# UNITED STATES PATENT AND TRADEMARK OFFICE

APPLICATION NO.	FILING DATE	FIRST NAMED INVENTOR	ATTORNEY DOCKET NO.	CONFIRMATION NO.
10/044,969	01/15/2002	Yousuke Moriuchi	026575-065	2991
7590	02/24/2005		EXAMINER	
Platon N. Mandros BURNS, DOANE, SWECKER & MATHIS, L.L.P. P.O. Box 1404 Alexandria, VA 22313-1404			PANTUCK, BRADFORD C	
			ART UNIT	PAPER NUMBER
			3731

<b>Office Action Summary</b>	<b>Application No.</b>	<b>Applicant(s)</b>	
	10/044,969	MORIUCHI ET AL. <i>CW</i>	
	<b>Examiner</b>	<b>Art Unit</b>	
	Bradford C Pantuck	3731

**DETAILED ACTION*****Claim Rejections - 35 USC § 102***

FIG. 10 (PCT/US99/00835)

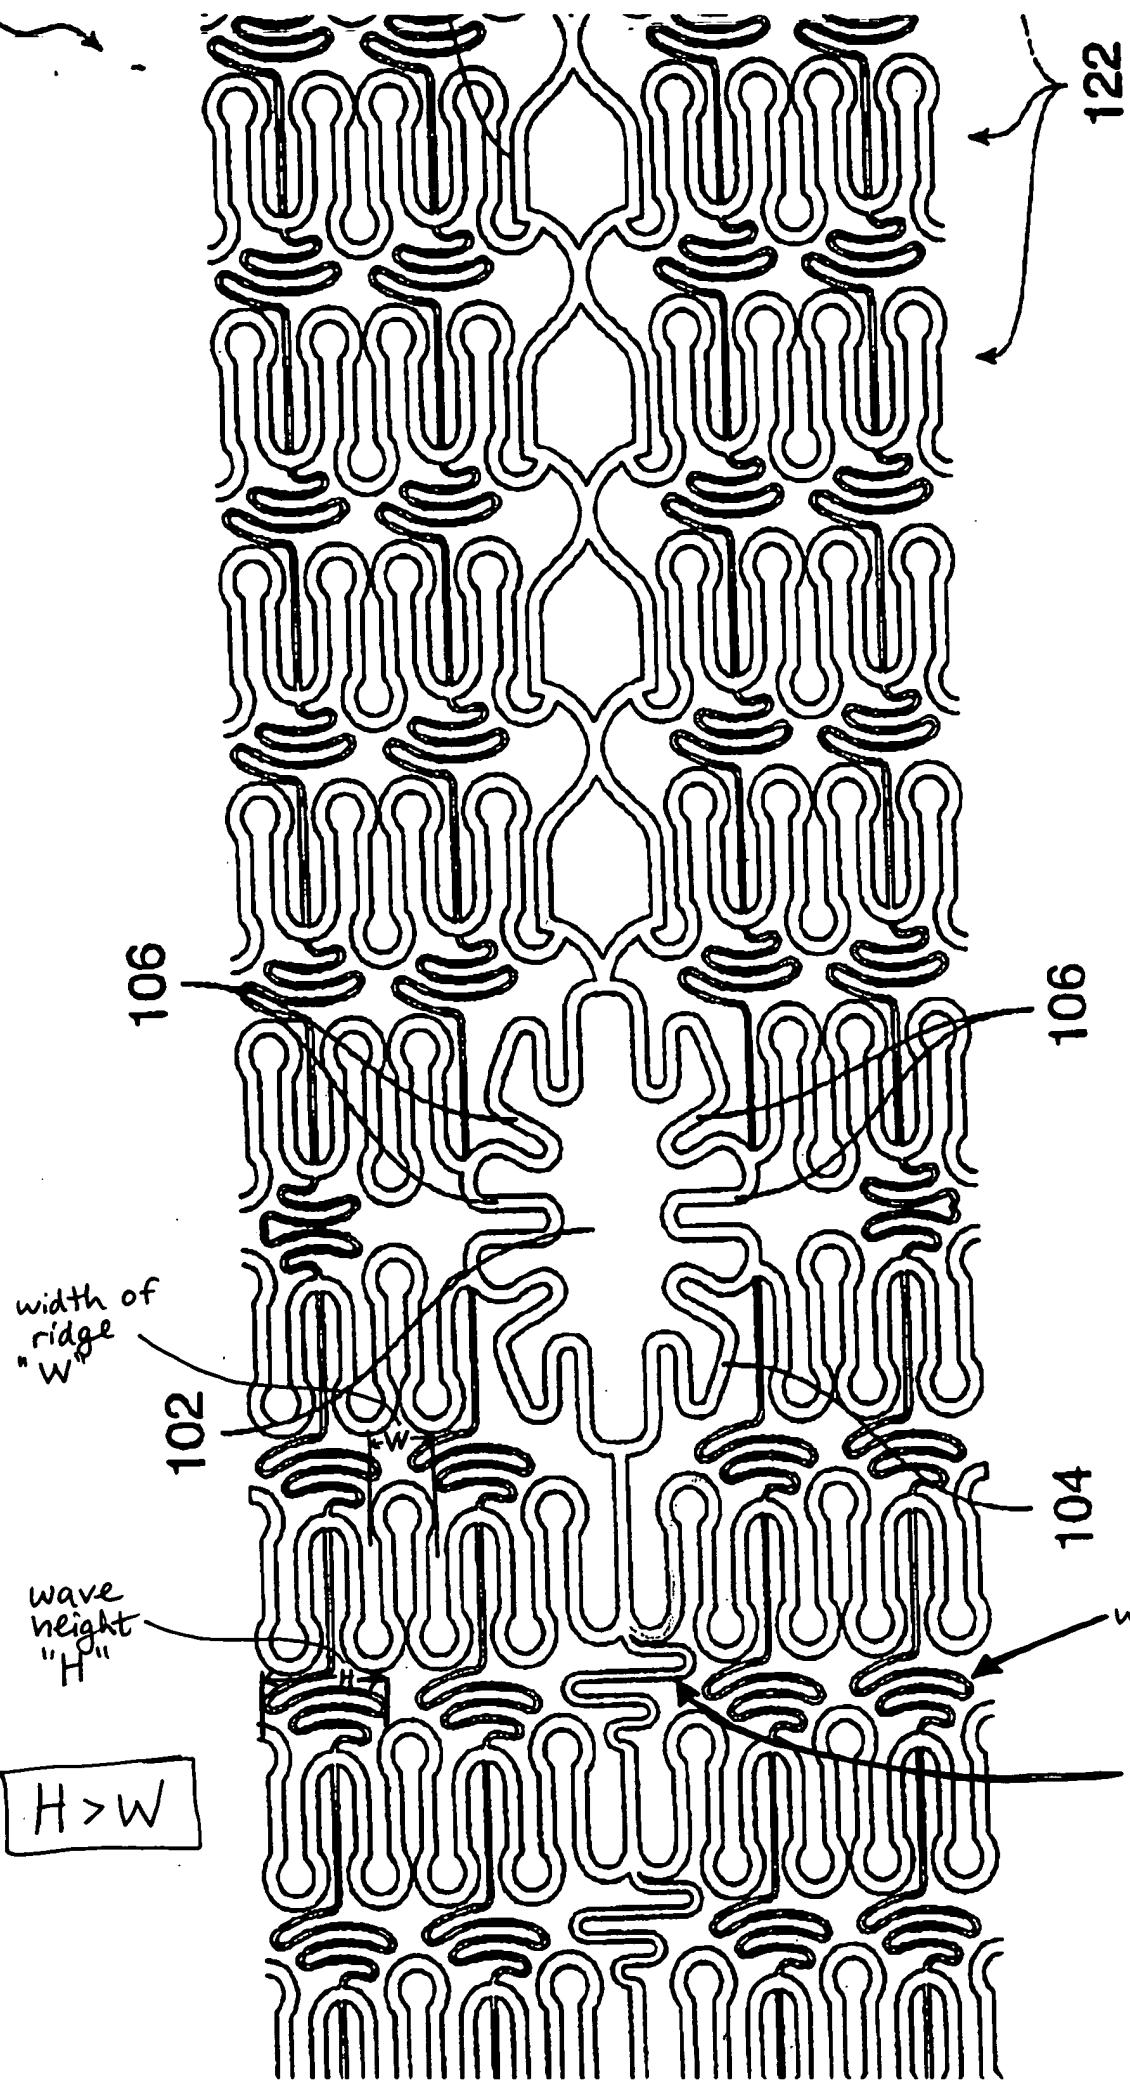
1. Claims 1-4, 6, 7, and 16 are rejected under 35 U.S.C. 102(b) as being anticipated by Publication No. WO 99/36002 to Vardi et al. Regarding Claim 1, Figure 10 shows an expanding stent with waved connecting members (114) having waves with varying amplitudes and the other features claimed by the Applicant.

2. Regarding Claim 2, waved connecting member “X” connects two bottoms of waved elements and connecting member “Y” connects two ridges of waved elements [see Attachment A].

3. Regarding Claim 3, upon visual inspection of the proportions shown in Figure 10, the width of each waved connecting member (114) is less than half the thickness of the waved elements of the annular expanding members. Further, because the Patent and Trademark Office does not have the testing facilities to provide factual evidence needed to establish that the claimed subject matter is not anticipated or unobvious, the examiner properly shifts the burden to applicants to show *unanticipated* or unobvious differences exist, *Ex parte Phillips*, 28 USPQ 1302 (Bd Pat App & Inter, 4/27/93).

5. Regarding Claim 6, the length of the Vardi's waved connecting member (114) is at least 1.3 times as much as the straight distance between ridges of the waved elements of adjacent annular expanding members, as measured in Fig. 10 using a string.

7. Regarding Claim 16, Vardi discloses waved connecting members each having four waves. Each trough or peak is considered to be one wave.

9. Applicant's arguments filed August 30, 2004 have been fully considered but they are not persuasive. WO 99/36002 to Vardi et al. discloses waved connecting members that meet the claimed subject matter that was added to claim 1, as illustrated in Attachment A (blown up view of Fig. 10 of WO 99/36002).
